# Access Compliance Report

## Public Rights-of-Way

Intersection ID: 31747	Main Street: LEAF_PLUM_DR	Cross Street: WASHOE_PINE_LN	Location: NW
ADA ID: DFA61112A875	Ramp Type: PerpDiag	Initial Pass/Fail: Fail	Overall Compliance: No
Severity Score: 46.25			
Codes/Mitigation Info/Possible Solution		Field Measurements/Component Compliance

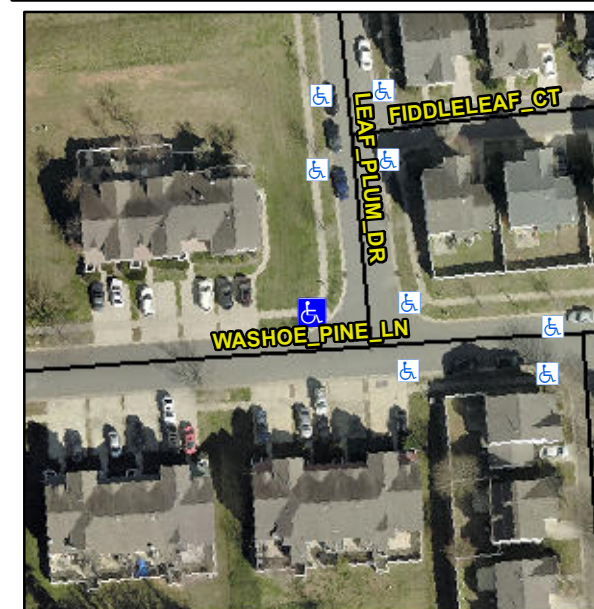
**Not Found, R304.5.1, R304.2.2, R304.5.3**

Compliance	Description	Data	Compliance	Description	Data
N/A	Ramp Length (in)	85.5	No	Ramp Slope (%)	8.9
No	Ramp Width (in)	47.5	No	Ramp XSlope (%)	9.5
N/A	Flare Type LT	N/A	N/A	Flare Type RT	N/A
N/A	Flare Slope LT (%)	N/A	N/A	Flare Slope RT (%)	N/A
N/A	Flare Traversable LT?	N/A	N/A	Flare Traversable RT?	N/A
N/A	Landing Length (in)	N/A	N/A	DWS Provided?	N/A
N/A	Landing Width (in)	N/A	N/A	DWS Contrast?	N/A
N/A	Landing Slope (%)	N/A	N/A	DWS Length (in)	N/A
N/A	Landing X Slope (%)	N/A	N/A	DWS Full Width?	N/A
N/A	Landing Curb? (Y/N)	N/A	N/A	DWS Offset (in)	N/A
N/A	Shared Landing?	N/A			
N/A	Gutter Ponding?	N/A	N/A	Gutter Slope (%)	N/A
N/A	Gutter Lip Ht (in)	N/A	N/A	Gutter X Slope (%)	N/A
N/A	Painted X Walk1?	No	N/A	Painted X Walk2?	No
	X Walk 1 Direction	To S		X Walk 2 Direction	To E
N/A	X Walk 1 Width (in)	N/A	N/A	X Walk 2 Width (in)	N/A
	X Walk 1 Slope (%)	2.3		X Walk 2 Slope (%)	6.8
	X Walk 1 X Slope (%)	6.5		X Walk 2 X Slope (%)	3.2

N/A	Ramp inside XWalk1?	N/A	N/A	Ramp inside XWalk2?	N/A
	Road Slope (%)	6.8	N/A	Clear Space?	N/A
	Road X Slope (%)	2.2	N/A	Clear Space to XWalk (in)	N/A
N/A	Any Obstructions?	N/A	N/A	Storm Grate/Utility Hazard?	N/A
	Obstruction Type			Storm Grate/Utility Type	
		N/A			N/A
			Yes	Surface Condition? (G/P)	Good

**Remove & Replace Curb Ramp With Two New Directional Ramps or Equivalent.**
